# **MUNICIPAL SOLID WASTE PERMIT MAJOR AMENDMENT-2<sup>ND</sup> NOD RESPONSE**

***NAME OF PROJECT: Beck Landfill***  
***MSW PERMIT APPLICATION NO.: 1848A***  
***OWNER: Nido, LTD (CN603075011)***  
***OPERATOR: Beck Landfill (RN102310968)***  
***CITY, COUNTY: Schertz, Guadalupe County***  
***Major Amendment: March 2023***

**REDLINE/STRIKETHROUGH VERSION**

**UTILITY TRENCH VENT DETAIL**

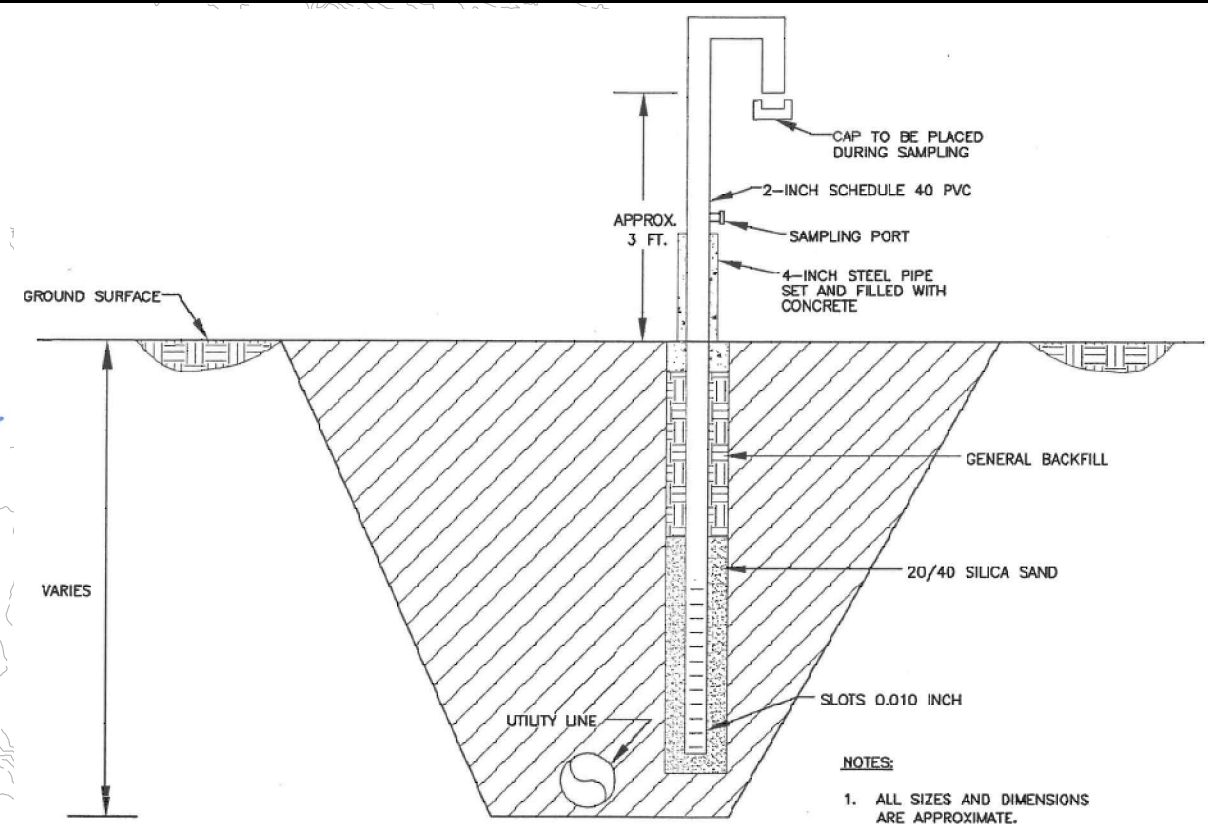
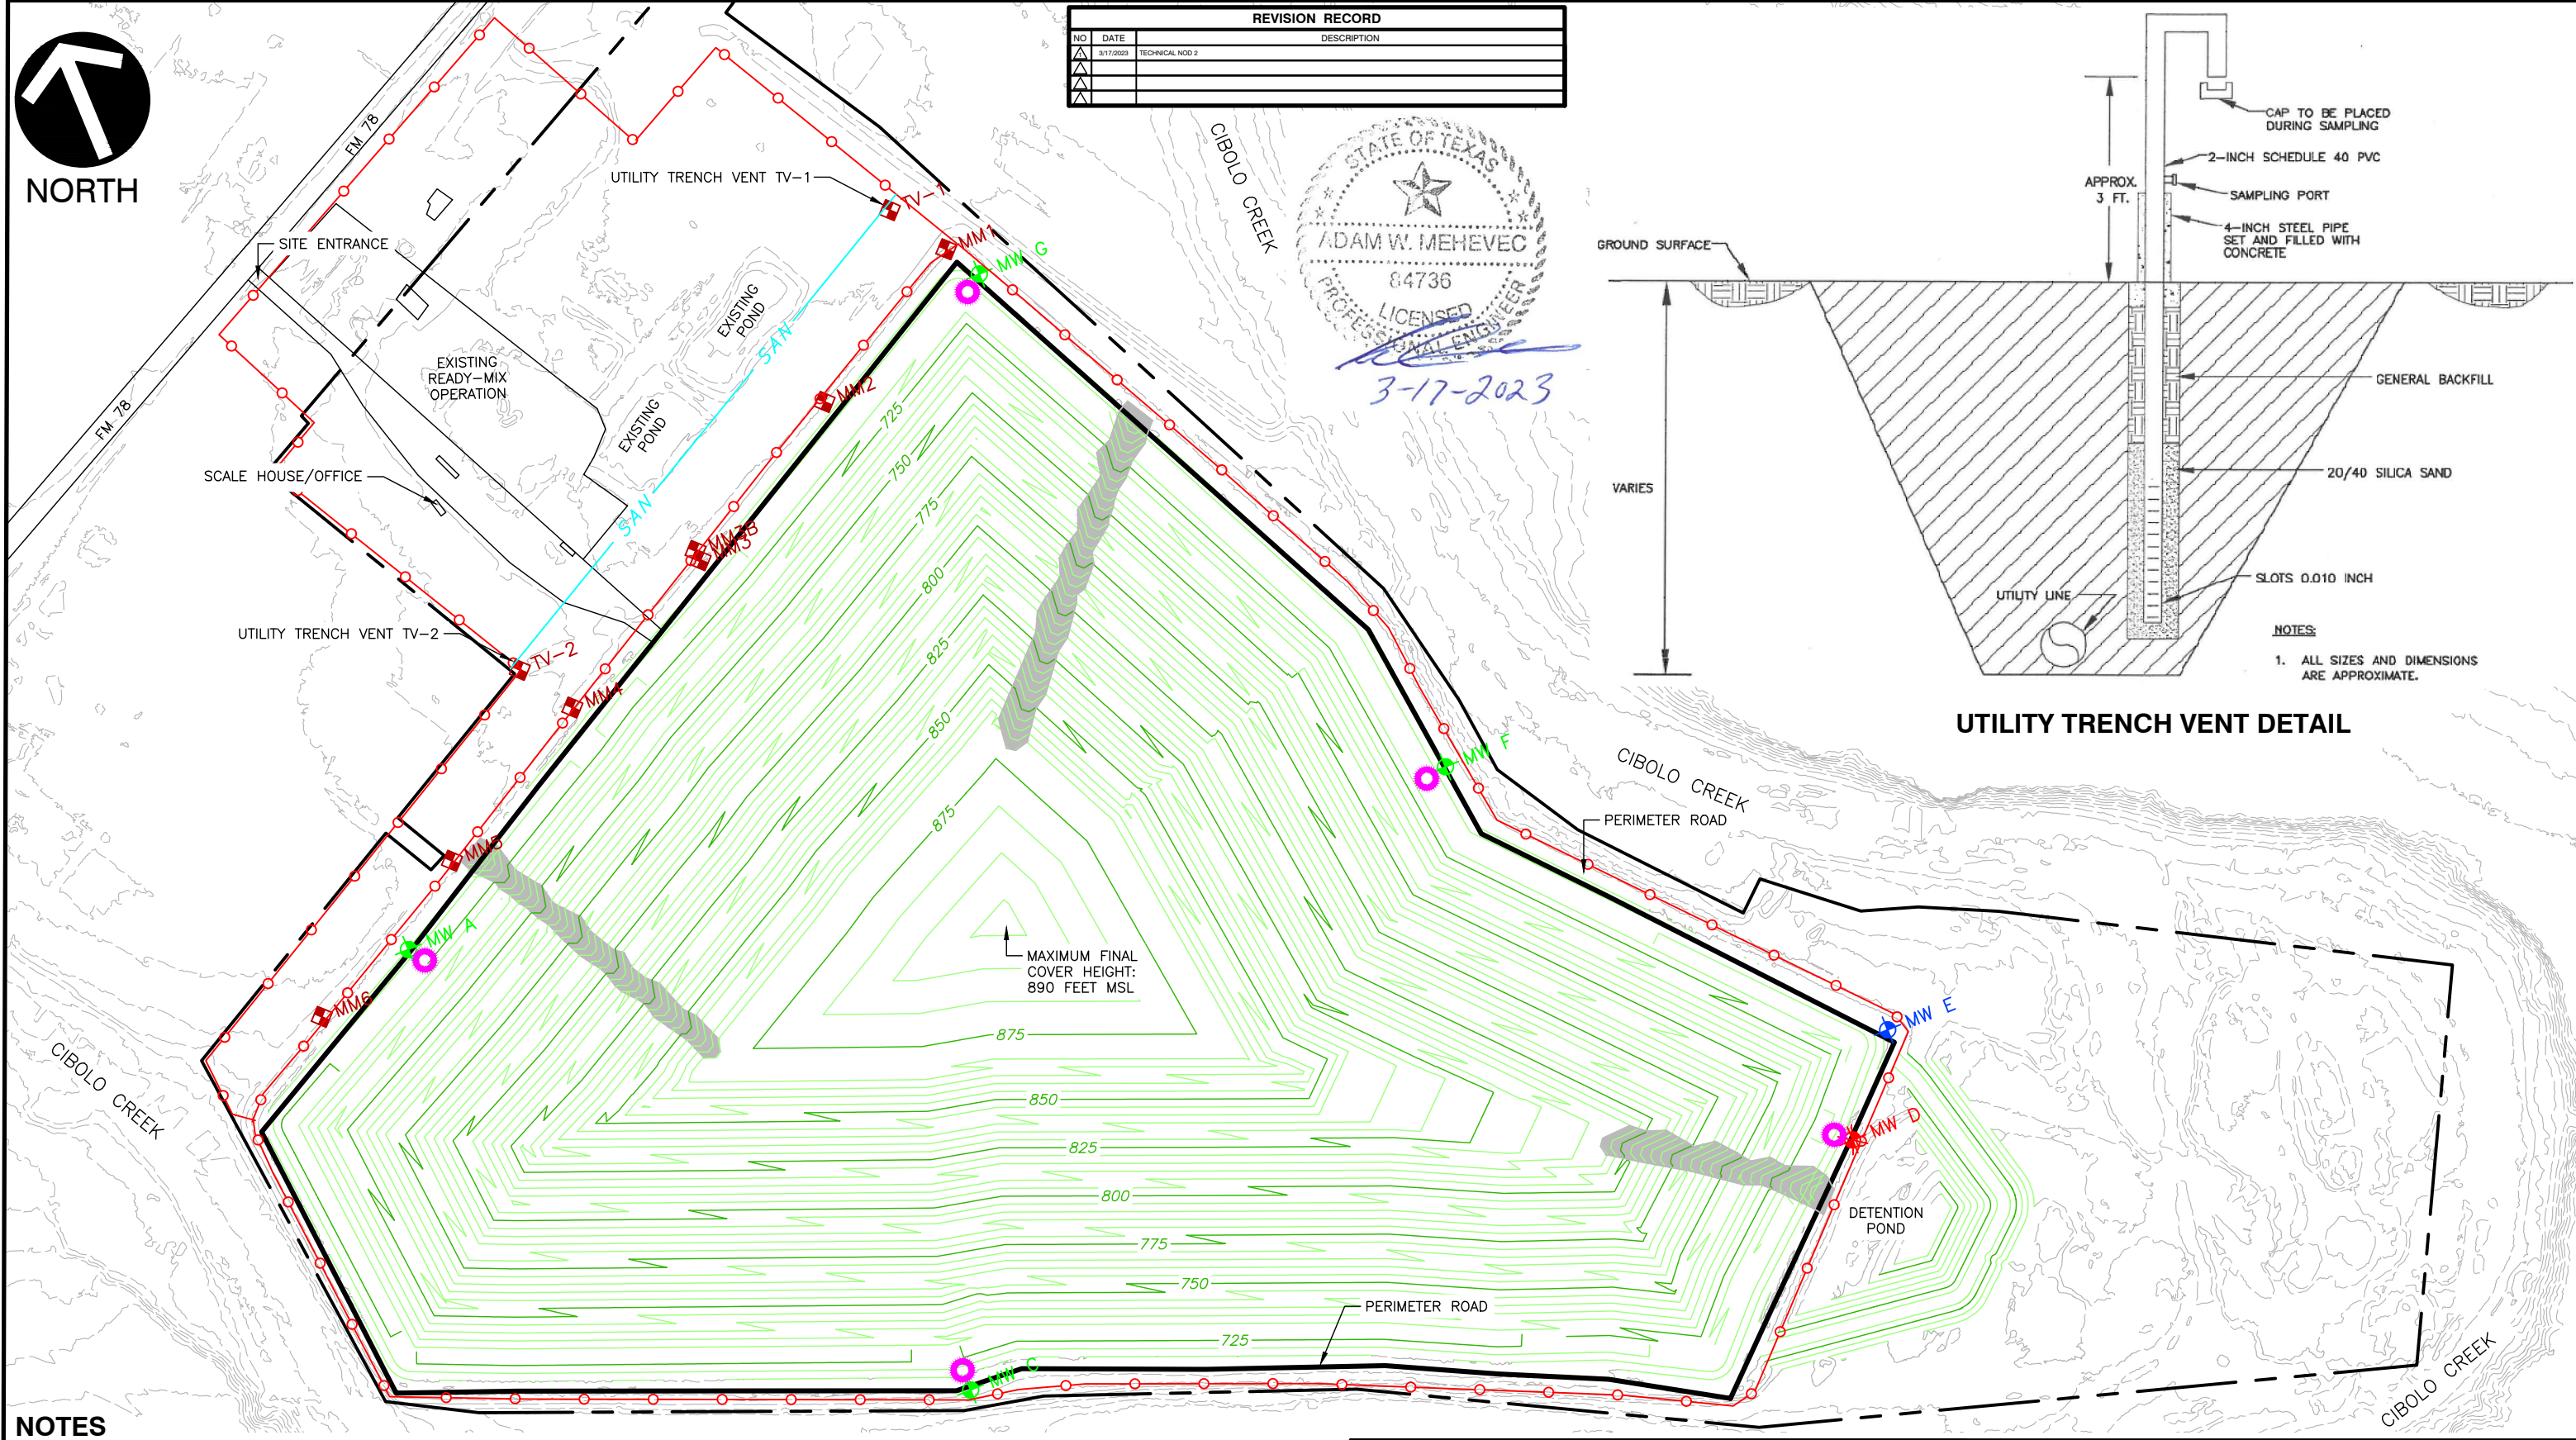
69	666	Part III	330.371(g)	Attachment G	Incomplete	Provide gas vents in utility trenches that cross the facility boundary and procedures for monitoring the vents.	Proposed gas vents are shown on Figure G-3 and procedures for monitoring the vents is included in Section 3.0 of Attachment G.
